Access Compliance Report Public Rights-of-Way (Curb Ramps)

Main Street: ROANOKE_DR		Cross Street: FLINTRIDGE_AVE		Location:	W
ADA ID: RPRK211108124717	Ramp Type: Type 4 - Parallel	Initial Pass/Fail: Fail	Overall Compliance: No	Severity Score:	16

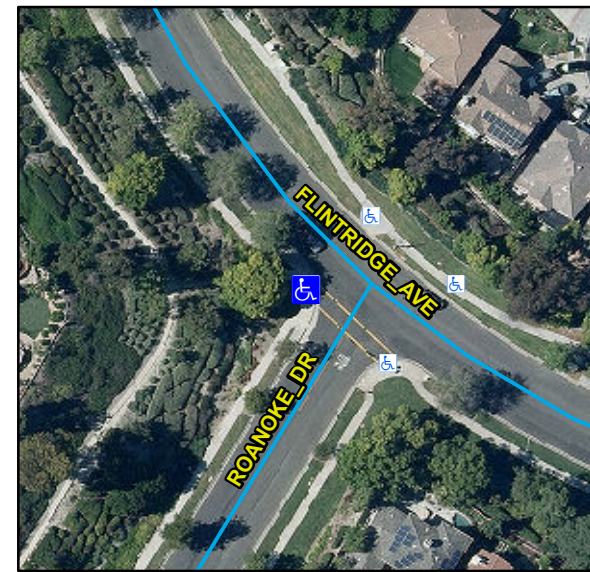
Compliance	Description	Data	Compliance	Description	Data
N/A	Ramp Length LT (in)	112	N/A	Ramp Length RT (in)	112
Yes	Ramp Width LT (in)	91	Yes	Ramp Width RT (in)	91
Yes	Ramp Run Slope LT (%)	0.9	No	Ramp Run Slope RT (%)	11.5
No	Ramp Cross Slope LT (%)	2.6	Yes	Ramp Cross Slope RT (%)	1.5
N/A	Landing Present	N/A	N/A	DWS Provided	N/A
N/A	Landing Length (in)	N/A	N/A	DWS Contrast	N/A
N/A	Landing Width (in)	N/A	N/A	DWS Length (in)	N/A
N/A	Landing Run Slope (%)	N/A	N/A	DWS Full Width	N/A
N/A	Landing Cross Slope (%)	N/A		DWS Offset Type	N/A
N/A	Landing Movement Obstructed?	N/A	N/A	DWS Offset Left (in)	N/A
	Landing Movement Type	N/A	N/A	DWS Offset Right (in)	N/A
N/A	Landing Shared	N/A			
N/A	Clear Space	Yes			
N/A	Clear Space To Crosswalk (in)	N/A			
N/A	Marked Crosswalk 1	Yes	N/A	Marked Crosswalk 2	No
	Crossing 1 Direction	SE		Crossing 2 Direction	NE
	Marked Crosswalk 1 Width (in)	144		Marked Crosswalk 2 Width (in)	N/A

N/A	Ramp Inside Crosswalk 1	Yes	N/A	Ramp Inside Crosswalk 2	N/A
	Crossing 1 Slope (%)	1.1		Crossing 2 Slope (%)	1.3
	Crossing 1 Cross Slope (%)	0.9		Crossing 2 Cross Slope (%)	5.1
N/A	Gutter Ponding	N/A	N/A	Curb Slope	1.2
Yes	Gutter Lip Height (in)	0		Road Run Slope (%)	3.5
N/A	Gutter Run Slope (%)	N/A		Road Cross Slope (%)	1.7
N/A	Gutter Cross Slope (%)	N/A	No	Perpendicular Joint Present	No
Yes	Overall Surface Condition	Acceptable			
	Cross Gutter Present?	No		Spandrel Present?	No
	Replace Cross Gutter?	N/A		Replace Spandrel?	N/A

Remove & Replace Curb Ramp With Two New Directional Ramps or Equivalent.
